TSA additions to ETS TLVs

az-carlson-TSAAdditions-0410-v0

TSA Additions to ETS TLV

Figure 38-4—ETS Configuration TLV format

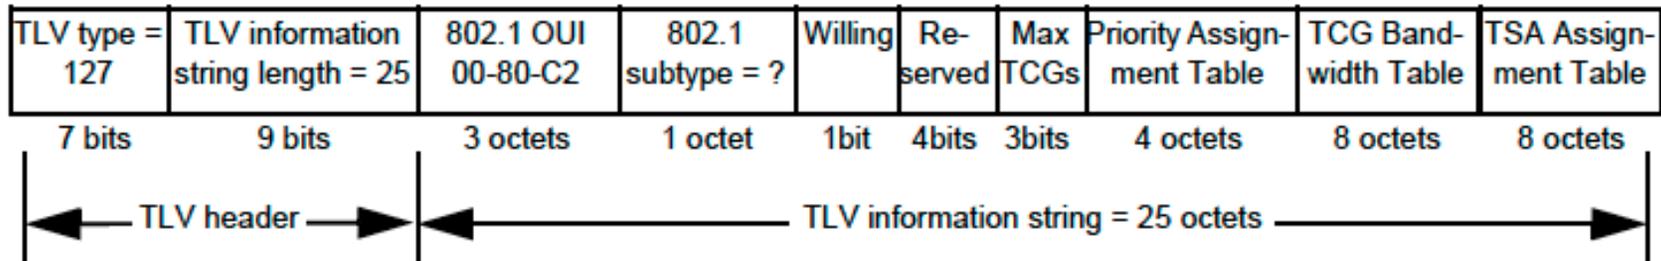
- At the March 802.1 DCB meeting it was decided to add the ability to send the TSA Table (Table 8-5 of P802.1REV-1.0) to the existing ETS TLVs
- A proposed format for this addition is shown here
